SUBJECT: Second suppl to 820407 application for Cycle 4 reload & uprate license amend. Further changes to App A Tech Specs necessary to allow Cycle 4 operation w/Exxon Nuclear Co fuel at 3,411 Mwt.

Donald C. Cook Nuclear Plant, Unit No. 2
Docket No. 50-316
License No. DPR-74
UNIT 2 CYCLE 4 TECHNICAL SPECIFICATIONS CHANGE REQUEST

ATTACHMENT NO. 1 TO AEP:NRC:0637E
DONALD C. COOK NUCLEAR PLANT, UNIT NO. 2
DESCRIPTION OF UNIT 2 CYCLE 4 TECHNICAL SPECIFICATION
CHANGE REQUESTS

Figure 2.1-1 Reactor Core Safety Limits -
Four Loops in Operation

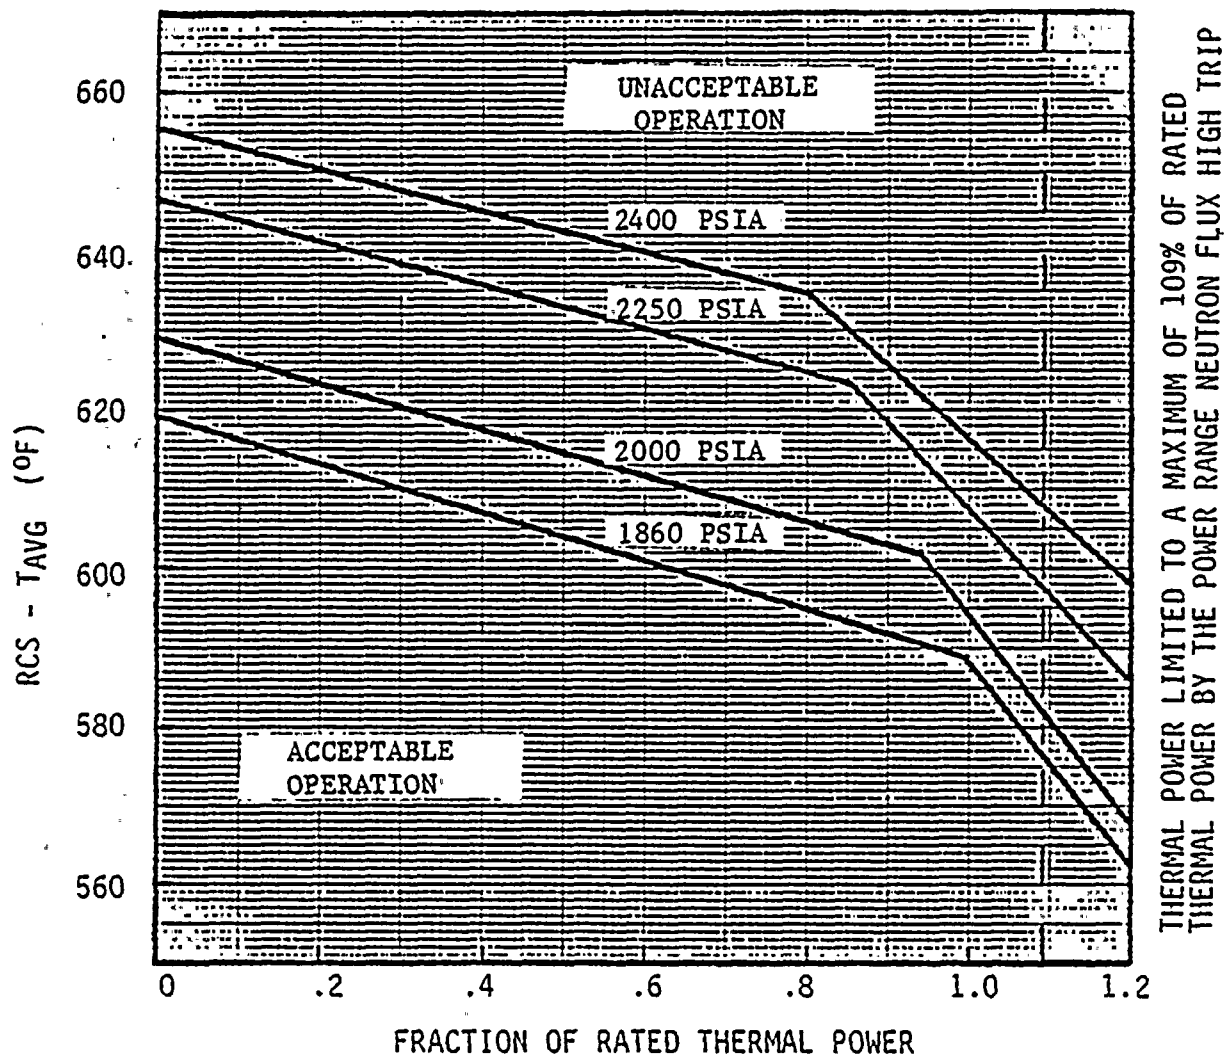
Core safety limit lines for the D. C. Cook Unit 2 reactor have been regenerated to include the effects of Exxon Nuclear Company's (ENC) XNB CHF correlation and a $F_{\Delta H}^N$ limit of 1.60. The safety limit lines define regions of reactor operation in terms of the system pressure, vessel average coolant temperature, and core power level. Operation within the safety limit lines ensures that the vessel hot leg temperature will be less than the saturation temperature and that the minimum departure from nucleate boiling ratio (MDNBR) will be greater than the safety limit value of 1.17 as calculated with the XNB critical heat flux correlation. These core safety limit lines are shown in Figure 2.1-1 for four-loop operation and in Figure 2.1-2 for three-loop operation.

It should be noted that the Core Safety Limit lines presented herein reflect the change in calculated DNB margin resulting from use of a measured non-mixing vane spacer loss coefficient in the XNB critical heat flux calculation. Previous ENC-generated Core Safety Limit lines, such as those presented in ENC Report No. XN-NF-82-32(P) entitled "Plant Transient Analysis for the Donald C. Cook Unit 2 Reactor at 3425 MWt", employed a loss coefficient calculated from the generalized de Stordeur equation.
